SECTION 00 91 13

ADDENDUM

Southern Cayuga Lake Intermunicipal Water Commission  
Bolton Point Water Pump Station  
Electrical Upgrades

Addendum No. 1  
Date Issued: March 20, 2026

NYS EXP.: 12/31/2028  
 Date: JANUARY, 2026  
 Scale: AS SHOWN  
 Sheet Number: **M101R**  
 Project Number: 677.006.001

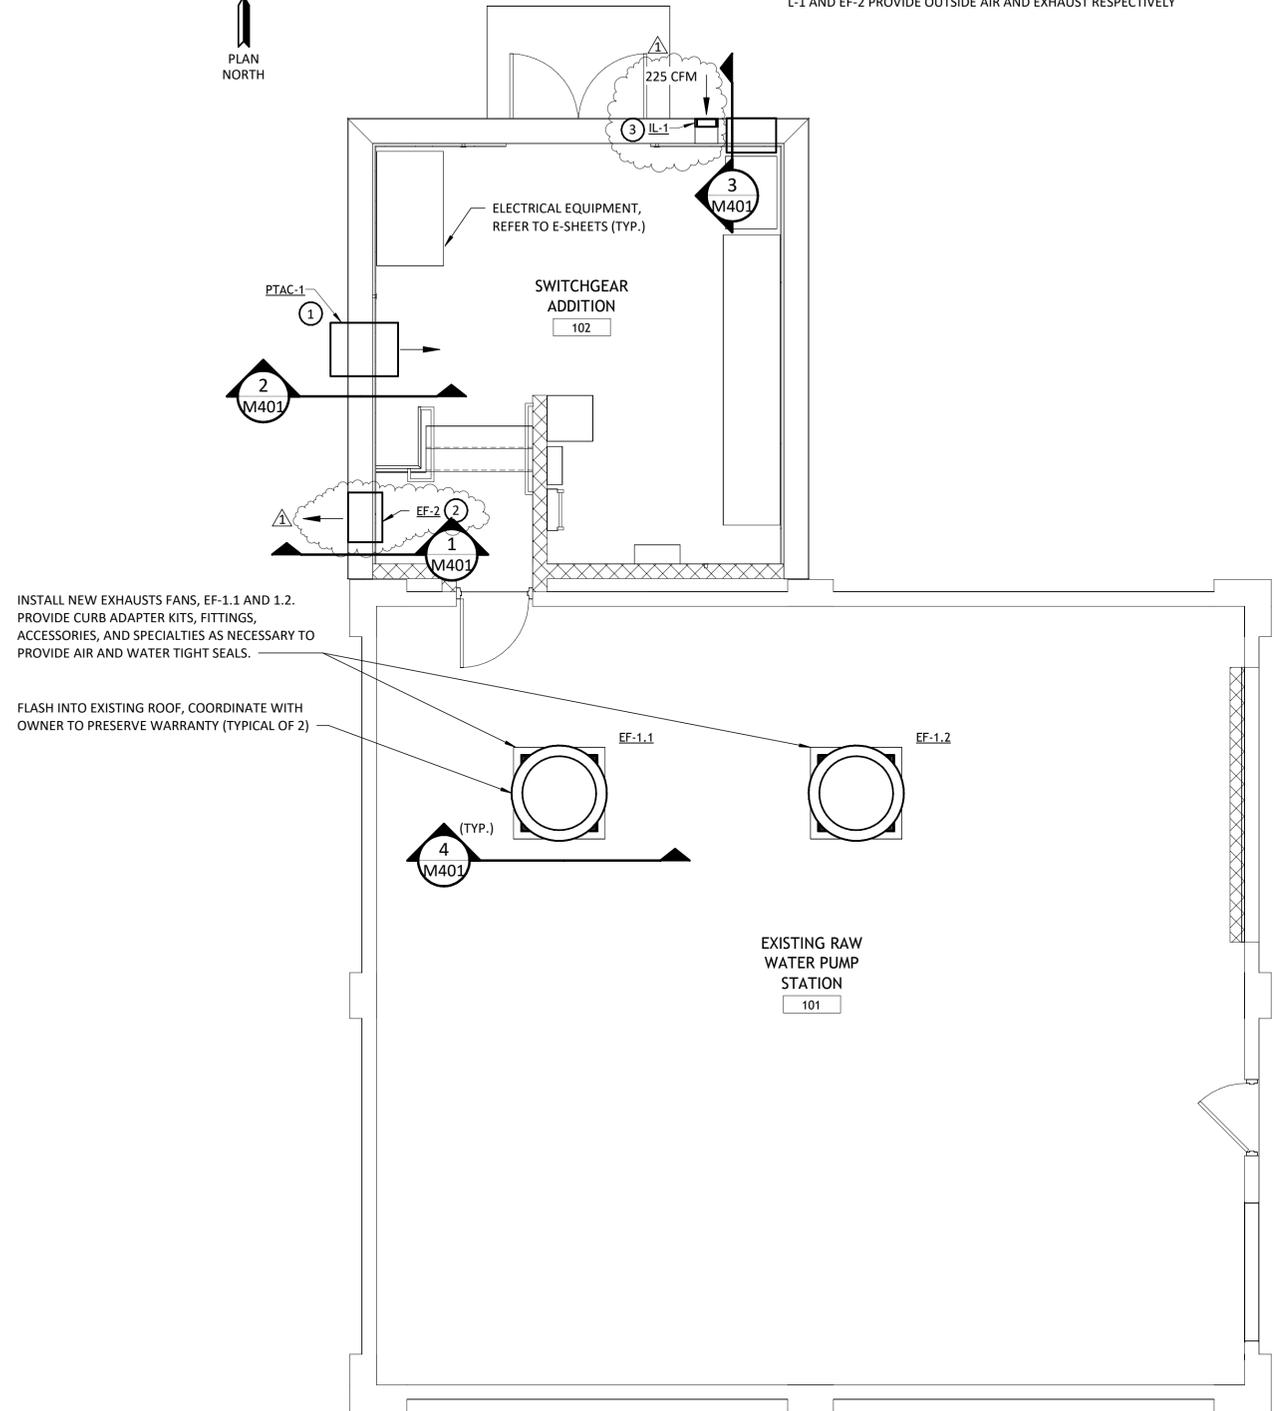
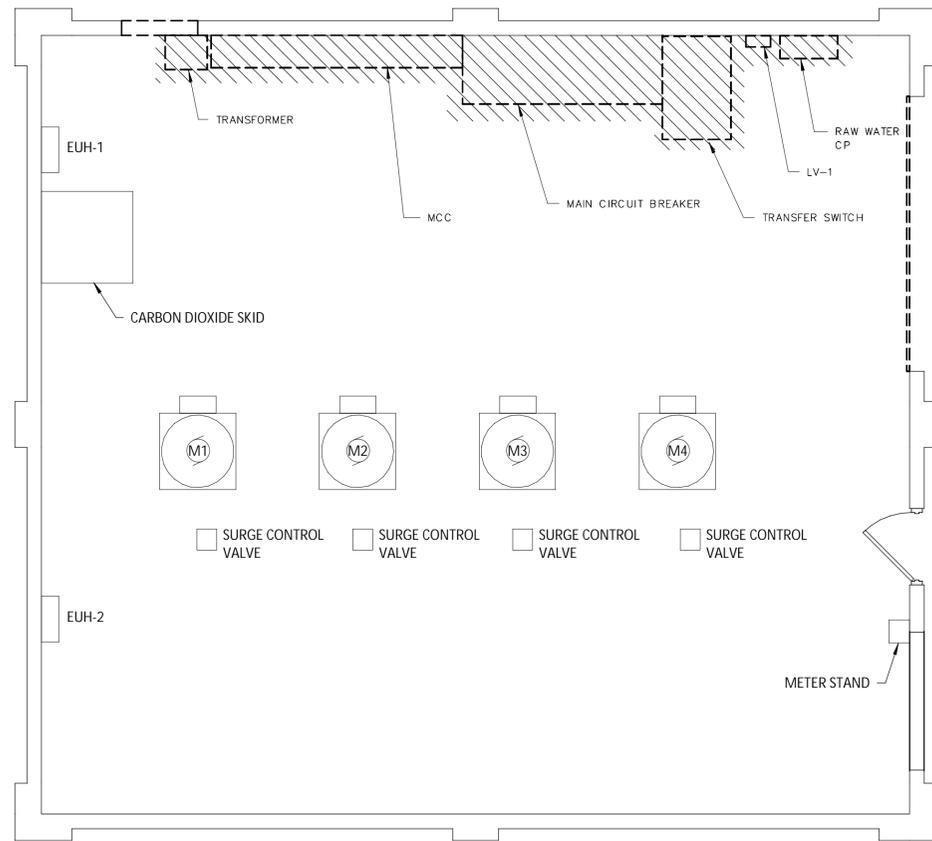
8. Question: Equipment RV-1 and RV-2 are referenced on the one-line diagrams but do not appear on the floor plans. Where are RV-1 and RV-2 located?

2. Reference: SHEET M101 – MECHANICAL DEMOLITION AND MODIFICATION PLANS
  - a. DELETE Sheet M101 in its entirety and SUBSTITUTE THEREFOR the revised Sheet M101 with Revision 1 Addendum 1, as attached to this Addendum No. 1.
3. Reference: SHEET E111 – PUMP STATION DEMOLITION AND MODIFICATION PLAN
  - a. DELETE Sheet E111 in its entirety and SUBSTITUTE THEREFOR the revised Sheet E111 with Revision 1 Addendum 1, as attached to this Addendum No. 1.

Response: See drawing M101. These are labeled as EF-1.1 and EF-1.2.
